Middle School

Summary update of diagnostic work performed from 7/5/05 through 7/26/05

Condenser fan cycling pressure switch photo #1429 (factory).

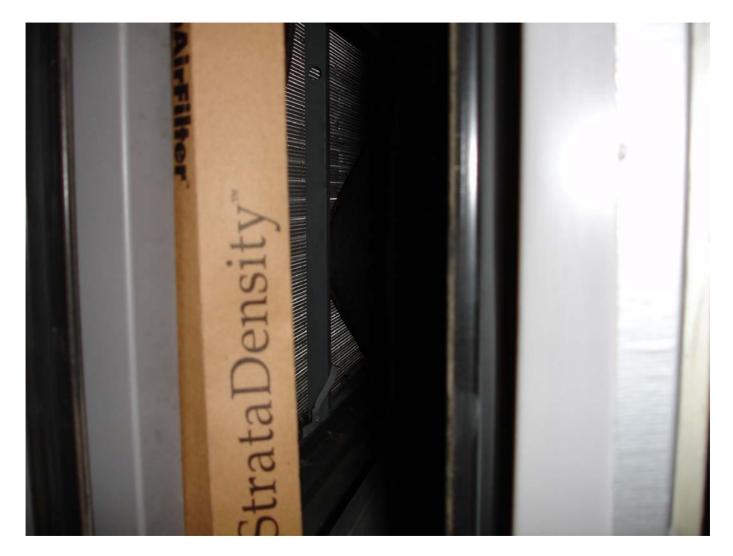
- The condenser fan pressure control is connected to the backseat port of the discharge service valve (factory). See photo #1429.

Piping penetration photo #1425.

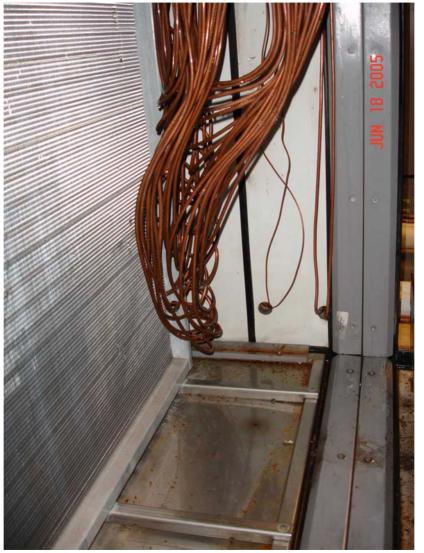
- Air filters plugged, incorrect depth, and dislodged from rack. See photo's #1414-1416.
- Insulation missing on #2 suction line. See photo #1423.
- Penetrations for refrigerant piping not sealed and in some cases the piping is in direct contact with the sheet metal casing which will result in a future leaks. See photo's #1425, 1426, 1483, 1484.

Expansion valve photo #1400 showing liquid entering suction line through external equalizer. Note condensate.

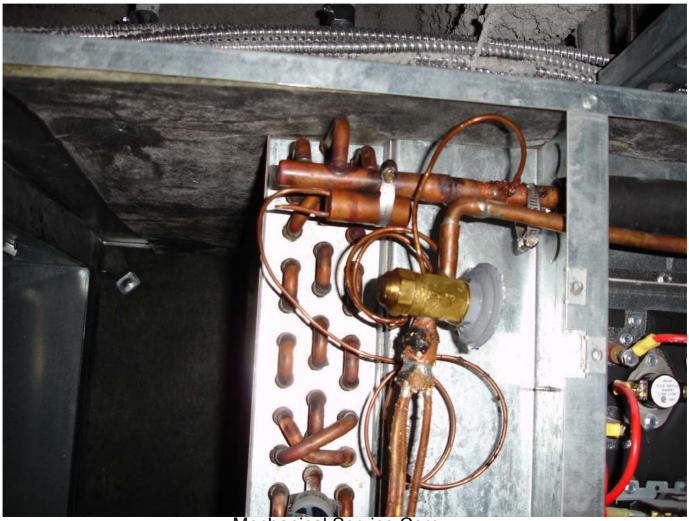
- Found faulty expansion valve. See photo's #1400, 1401.
- Dirty filter. See photo's #1396, 1397.

None. Reported problem to construction manager and correction was assigned to others. Disposition unknown.

Air handler 6, Photo #1409

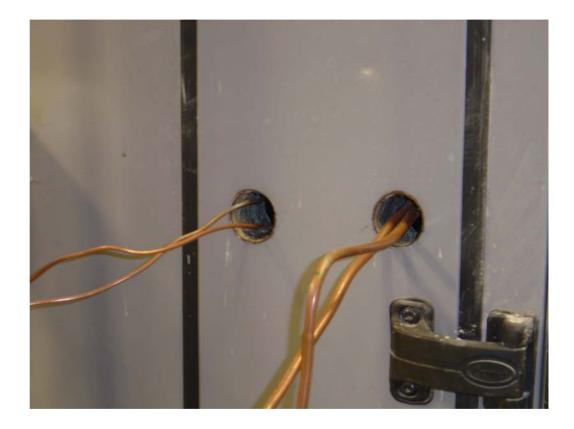
Suction line insulation missing which adds to condensate problem.

Condensing unit 6, photo #1419

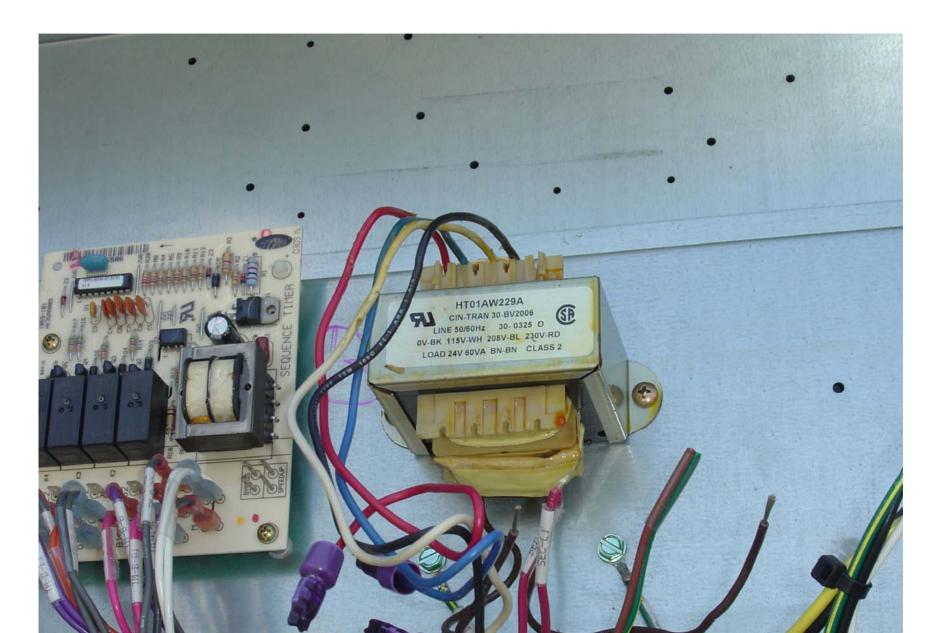
- Missing refrigeration valve caps.
- Evidence of leaking due to missing cap.

Attic finned tube radiation

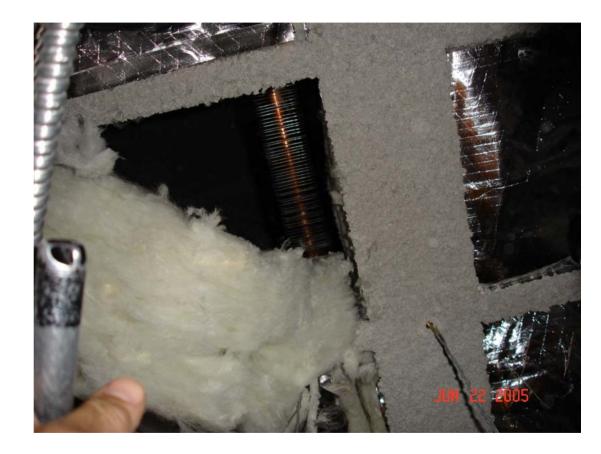
• Attic loop is piped to the main boiler loop (180 deg). Attic loop water is not reset based on outdoor temperature.

Unable to locate source of control. Valve is in the 100% open position.
 Anytime the boiler pumps are on this will allow full flow.

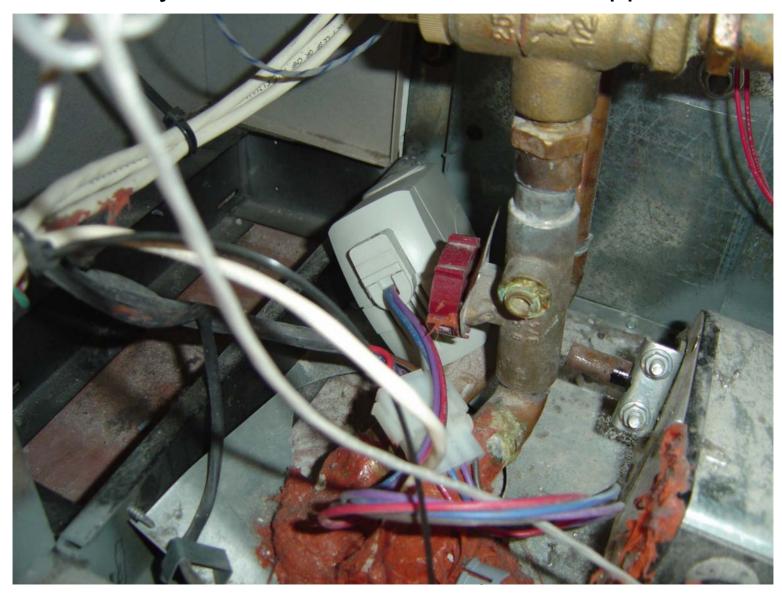
Electrical panel insulation loose. Insulation glues to the bottom of the electrical panel.

Improper filter installation.

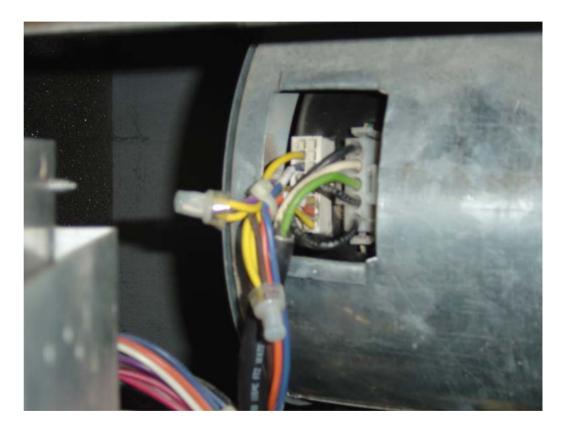
The fan motor power and control connectors were found disconnected on room 111. The fan was not operating but the compressor was still cycling on and off on the mechanical freeze-stat supplied by the manufacturer.

Ultrasonic flow meter. Shows GPM flow on radiant loop as found.

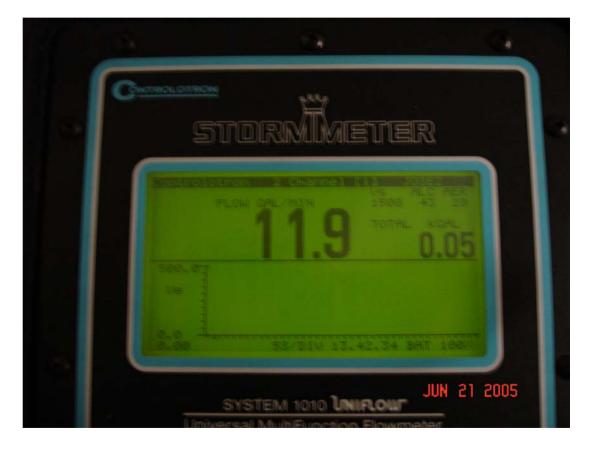
- Pump PR1 / PR2 (radiation pumps) flow found at 11.9 GPM at the pump station. (see photo #1559). Design flow is 40 GPM. Balancer's report shows a flow of 12.2 GPM.
- Flow rate at the Principals' office varied from 0.36 to 0.45 GPM (design is 0.98 GPM). Flow dropped to 0.26 GPM when the zone valve in an adjacent room was opened.
- No pressure taps on pumps to allow a cutoff test.
- Strainers clean.
- Found 2" circuit setter closed. The 1" circuit setter was 100% open.

- Set 2" circuit setter to fully open. Pump flow increased to 49.5 GPM.
- Set the circuit setter to approximately 30 GPM to distribute as intended by the Engineer.
- Re-measured flow in Principals' office at 1.48 GPM. No true balancing valve installed to balance each zone of baseboard.
